SERVICE LETTER NO. SL-1

EFFECTIVITY: Rockwell Commander 112 S/N 3 through 79

SUBJECT: Rudder Assembly

Figure 1.

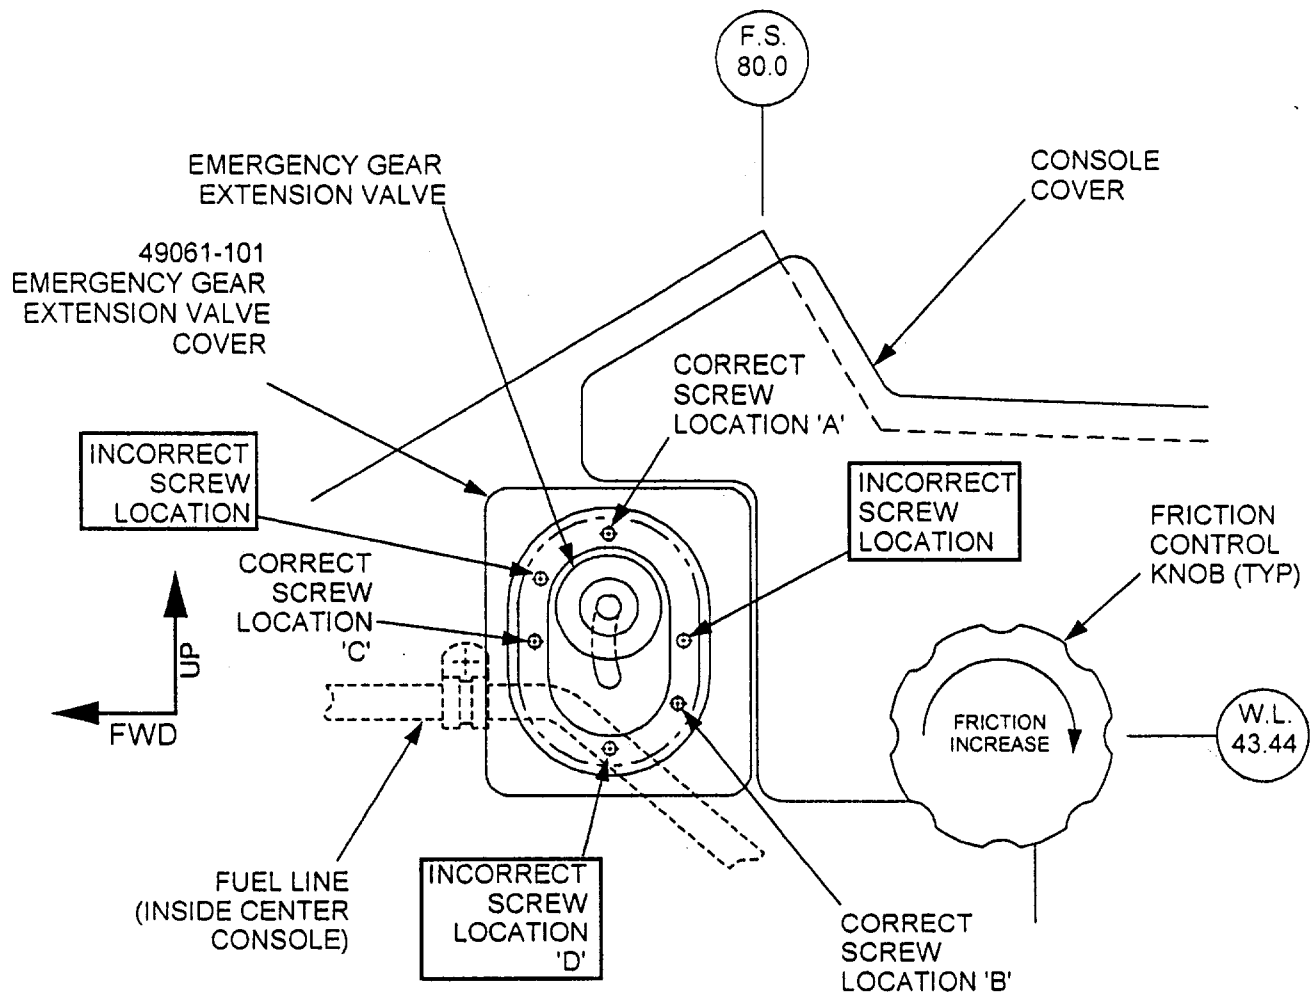
1. Remove the three screws attaching the Emergency Gear Extension Valve Cover to the center console and discard the screws. Set the cover aside for later use.
2. Carefully peel the carpet away from the center console so that the area around the Emergency Gear Extension Valve is exposed.
3. Refer to Figure 1. Examine the area around the Emergency Gear Extension Valve. Verify that the location holes for the three screws attaching the Emergency Gear Extension Valve Cover to the center console match the correct hole locations A, B, and C.
4. If there is an attachment screw hole at location D indicating that the Emergency Gear Extension Valve Cover was installed upside down at some point, proceed to Part II.
5. If the cover was installed correctly and there is no additional attachment screw hole at location D, proceed to Part IV.

Figure 2.

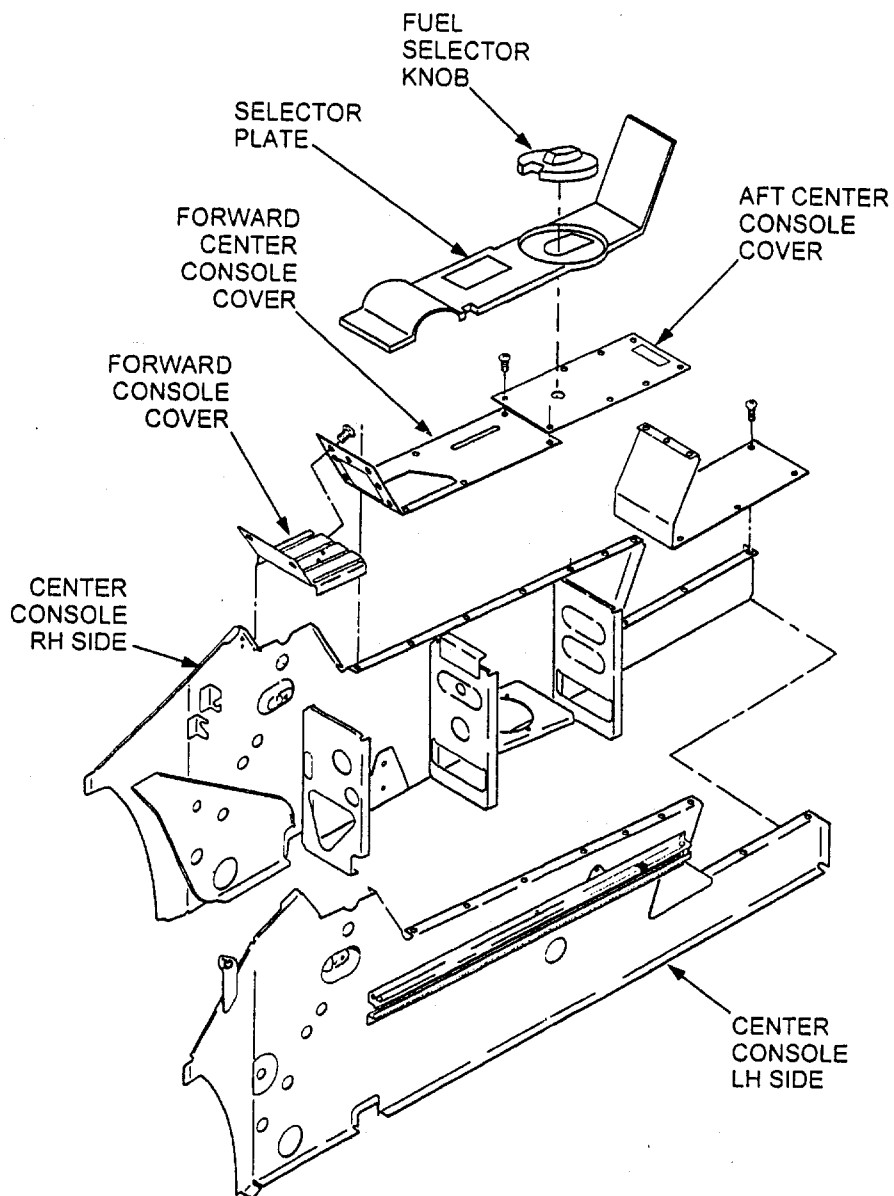
1. Remove the screw attaching the forward and aft center console covers to the center console and remove the covers from the center console. Refer to Figure 2.
2. Remove the two clamps securing the Fuel Line to the side of the center console.
3. Disconnect any bindings tying the static line to the Fuel Line.
4. Loosen the fitting connecting the Fuel Line to the fuel selector valve.

Figure 3. Cover Plate Modifications

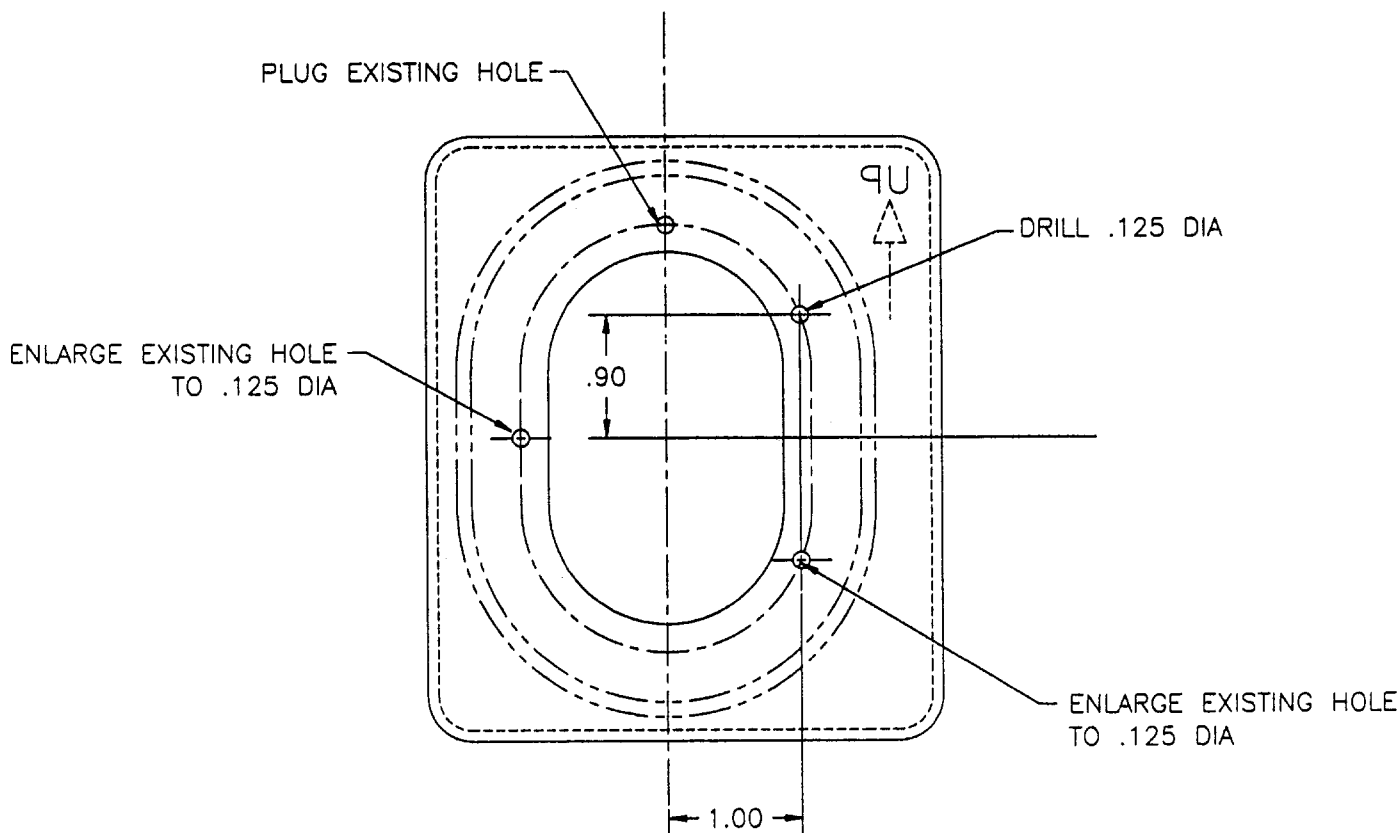
1. Refer to Figure 3. Plug the existing upper hole of the Emergency Gear Extension Valve Cover Plate with Duramix #4040 or equivalent.
2. Enlarge the two remaining holes to .125 diameter.

3. Drill an additional .125 diameter hole in the location shown in Figure 3.
4. Paint the cover plate to match the interior of the aircraft.
5. When the paint is dry, draw an arrow and write the word 'UP' on the back side of the plate in a contrasting color as shown in Figure 4.

Figure 5.

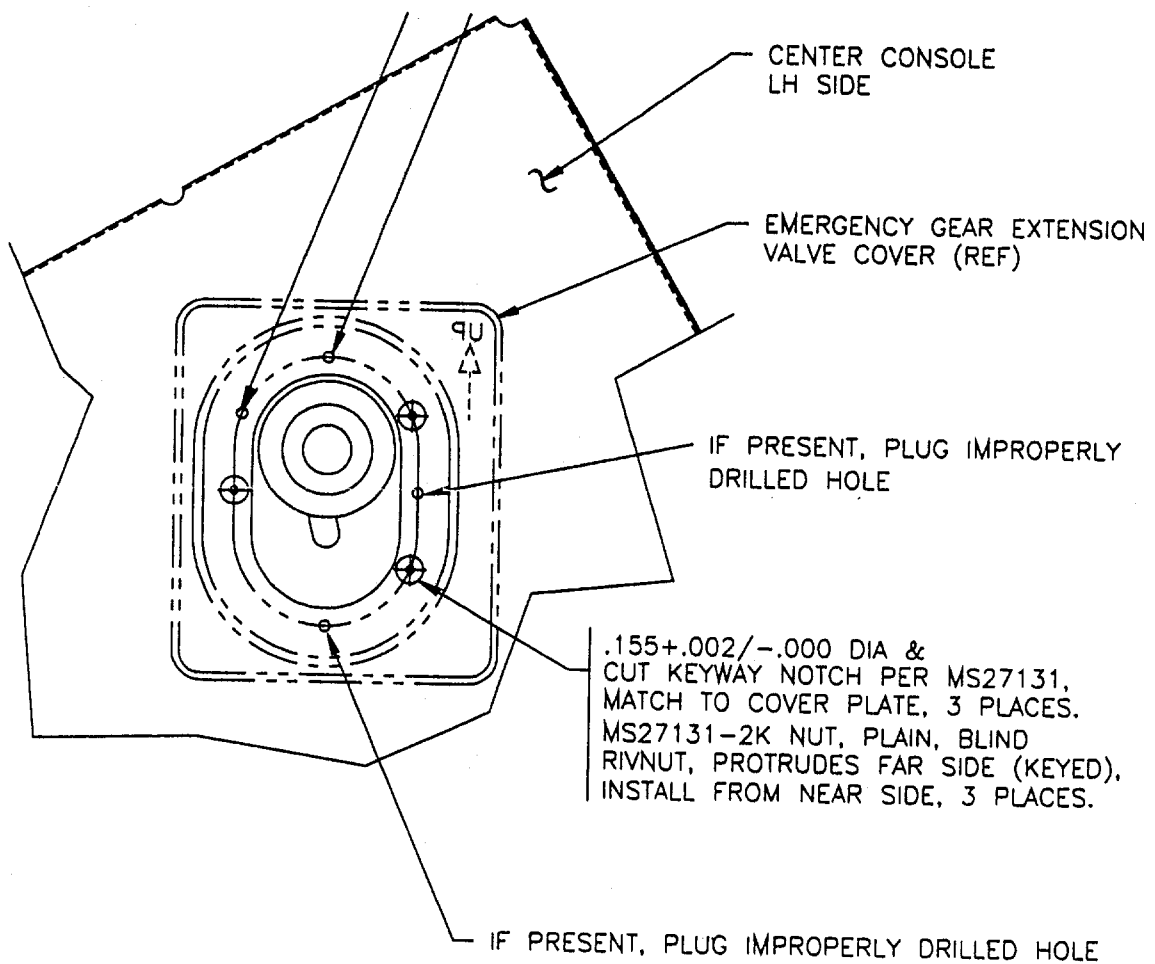
7. Cut the keyway notches in the three attachment holes as shown in Figure 5. Install three MS27131-2K Rivnuts.
8. Plug the old upper attachment hole and any improperly drilled attachment holes with any of the following:

Figure 6.

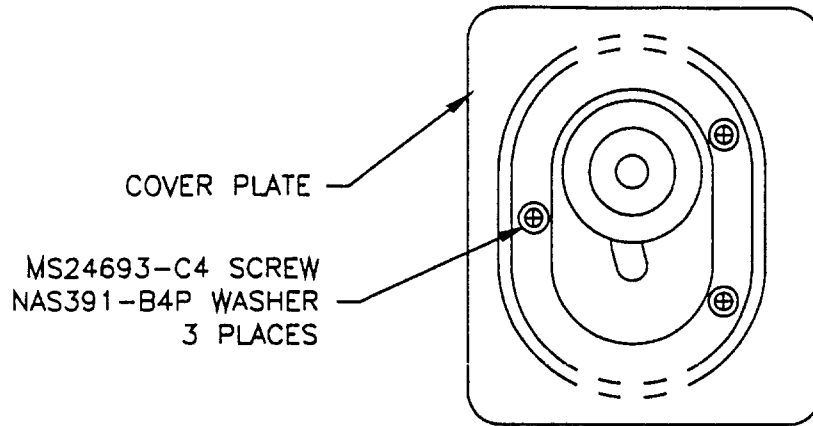
- a. CR2673-3-01 Rivet
 - b. CR2249-4-01 Rivet
 - c. Driven BJ-3 or BJ-4 Rivets.
9. Reattach the carpet to the center console.
10. Reattach the cover plate using three MS24693-C4 Screws and three NAS391-B4P Washers as shown in Figure 6.

Figure 1.

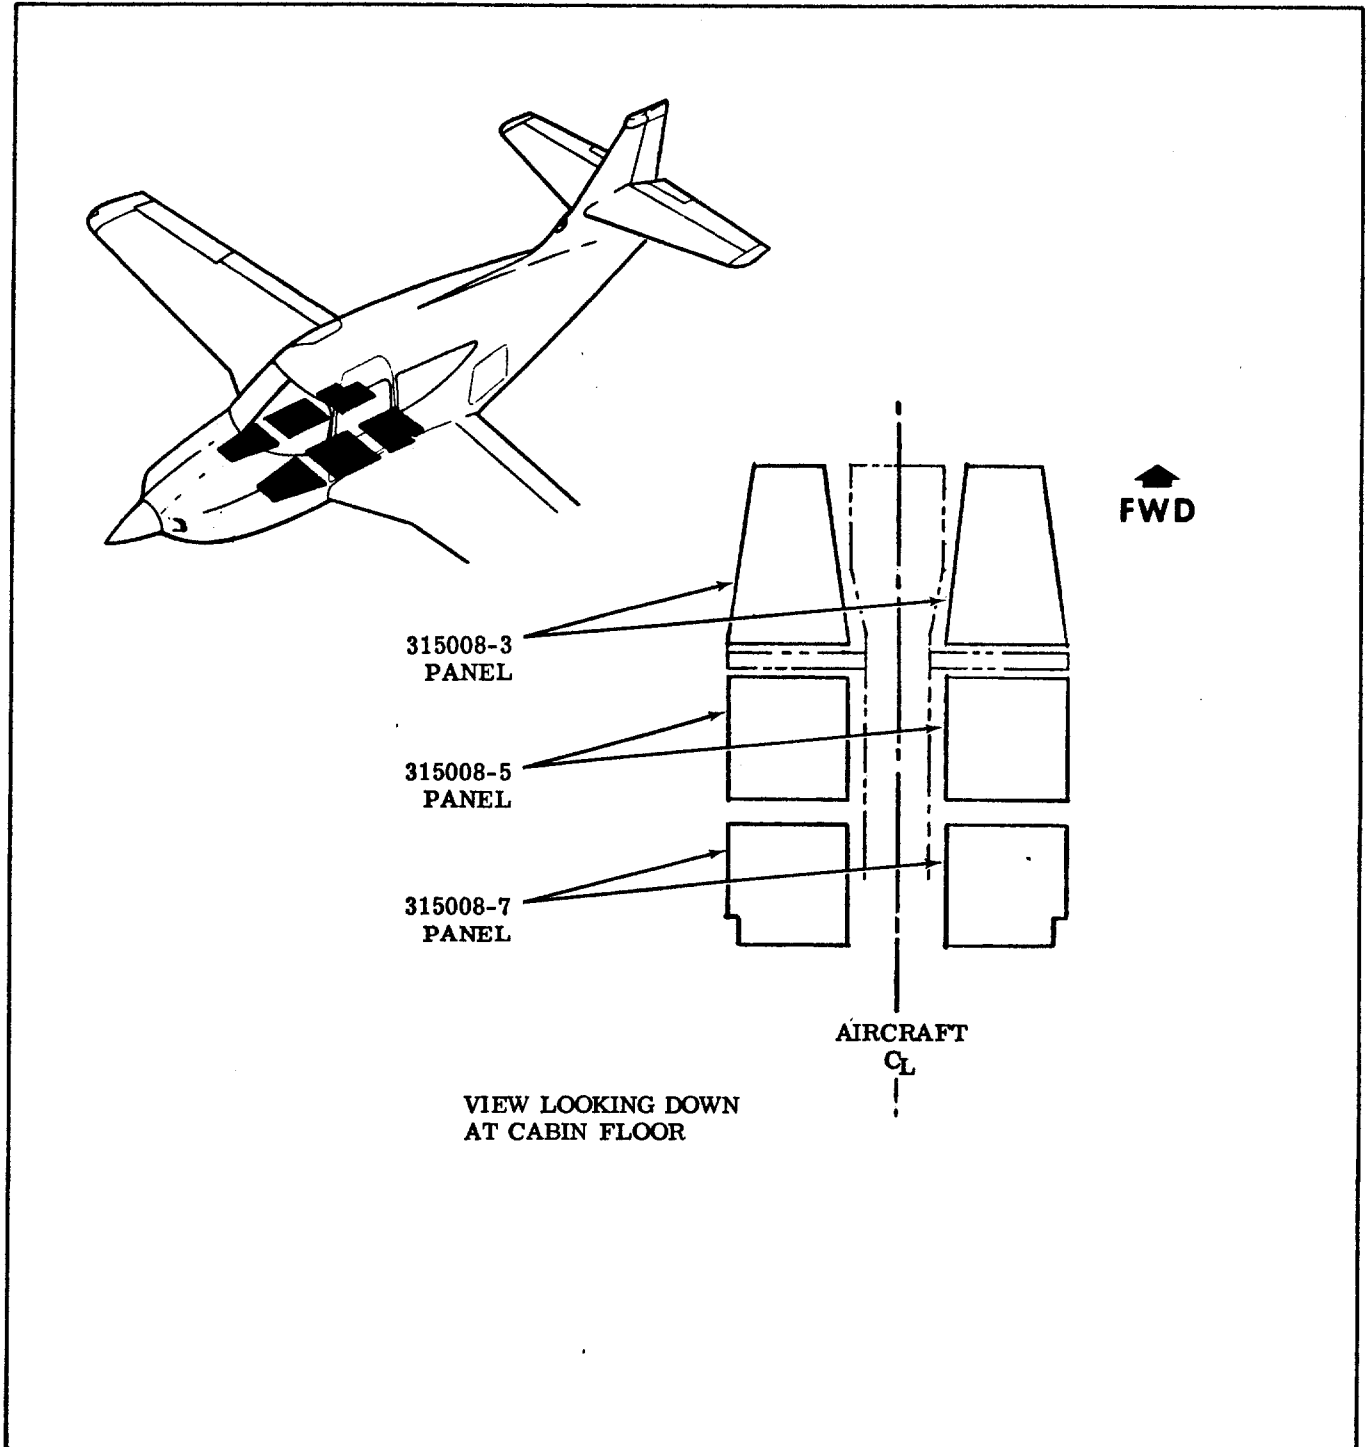
1. Sand all areas where noise reduction panels are to be installed with 400 grit sandpaper (see Figures 1 and 2.).
2. Wipe sanded area clean with Stoddard solvent or equivalent.
3. Install 315007-3 and -4 stiffeners and 315007-5 and -6 clips as shown in Figure 2.

Figure 2.

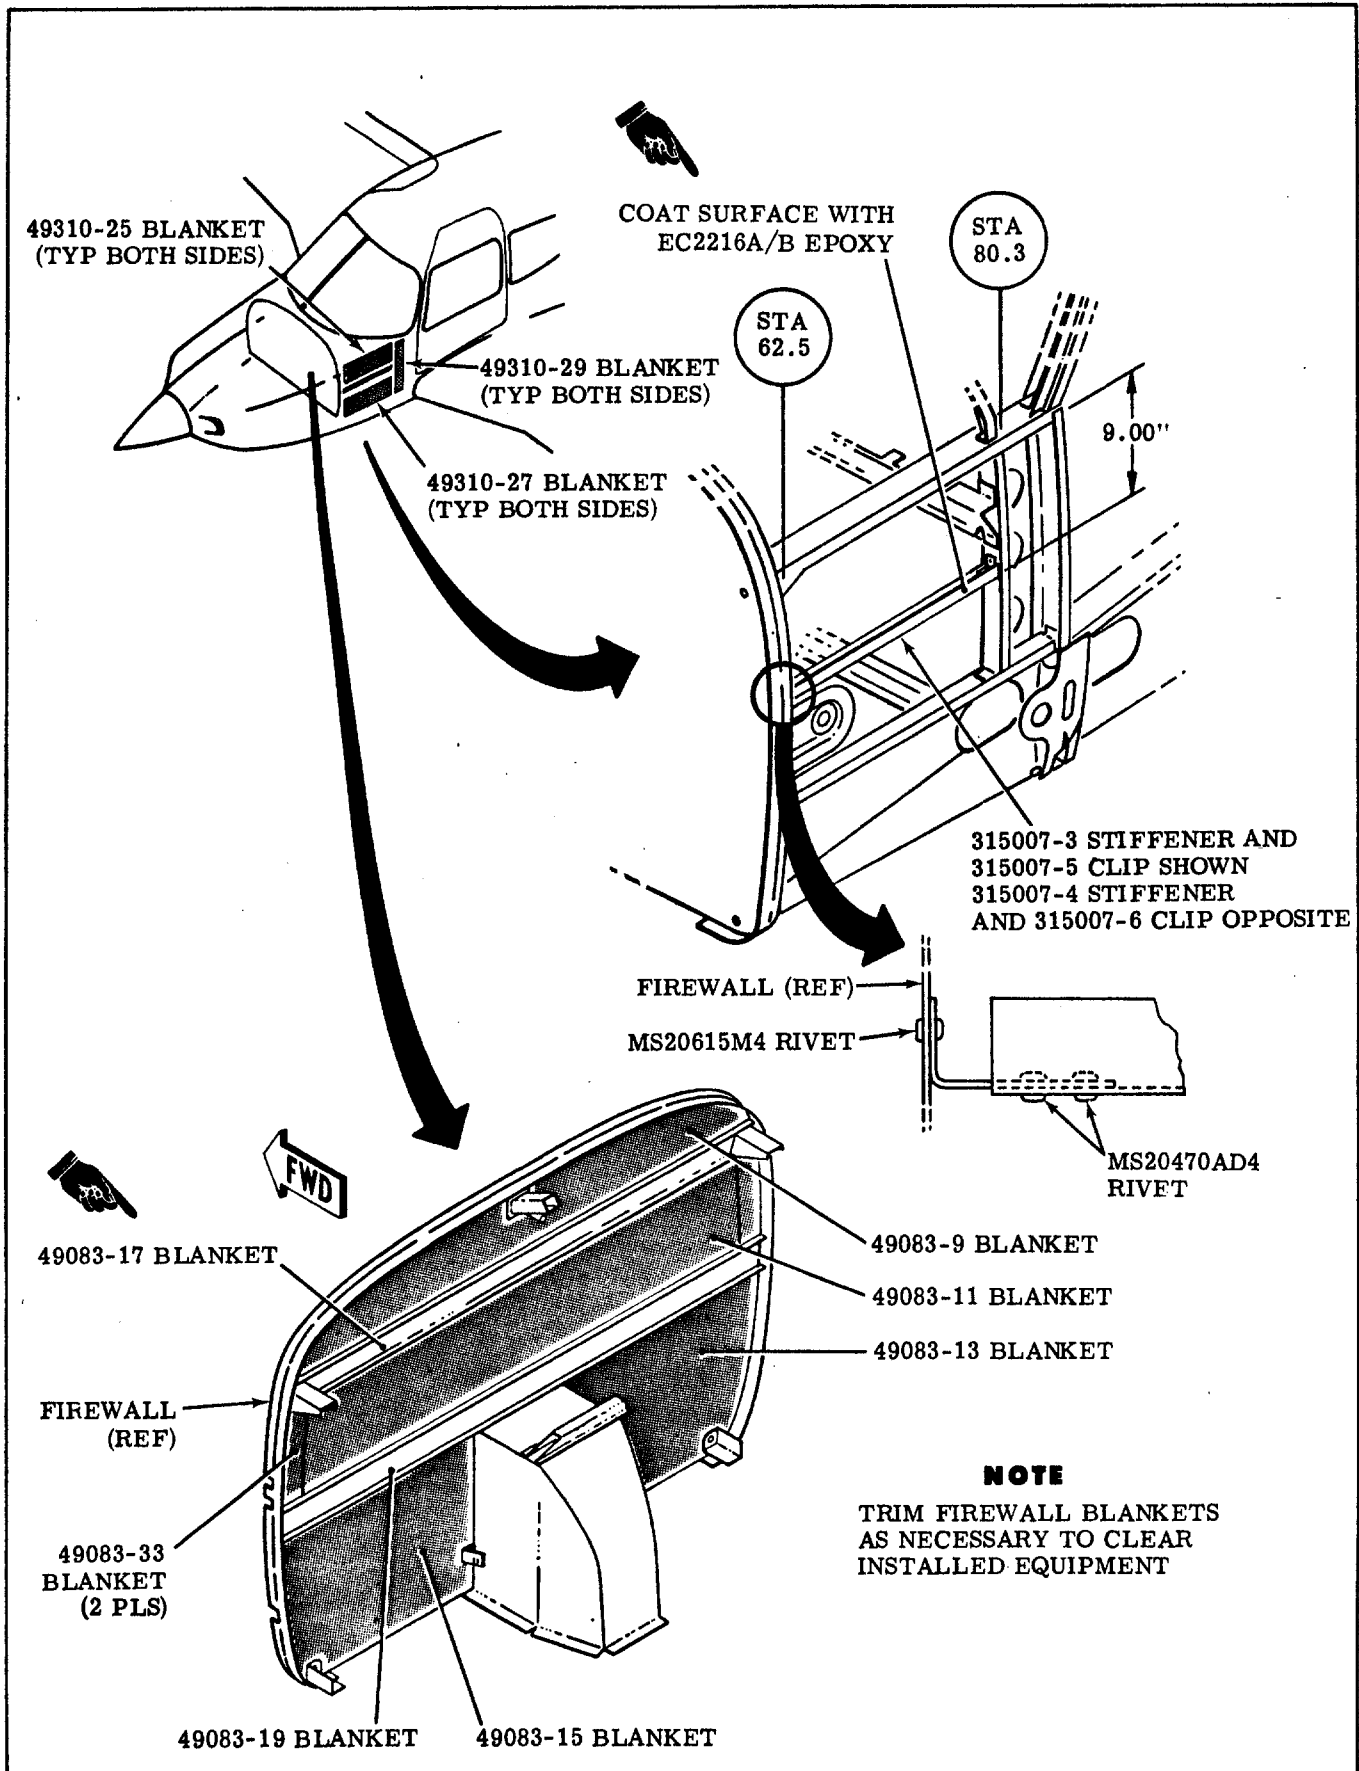
4. Cut and trim 49083 blankets as required to clear equipment installed on aft side of engine firewall (see Figure 2.).
5. Apply EC1403 adhesive to rubber side of trimmed blankets and attach to firewall.
6. Cut and trim 49310-25 and -27 blankets as required to install above and below stiffeners installed in step 3. above.
7. Apply EC1403 adhesive to trimmed blankets and attach to fuselage skin (see Figure 2.).
8. Install 49310-29 blankets by inserting blanket through airframe lightening holes.
9. Reclean floor area with Stoddard solvent or equivalent.
10. Immediately after cleaning floor area apply 2-part EC2216 A/B Epoxy to cleaned area.
11. Press 315008 panels in place and utilize weights to hold panels against floor surface until epoxy has cured.
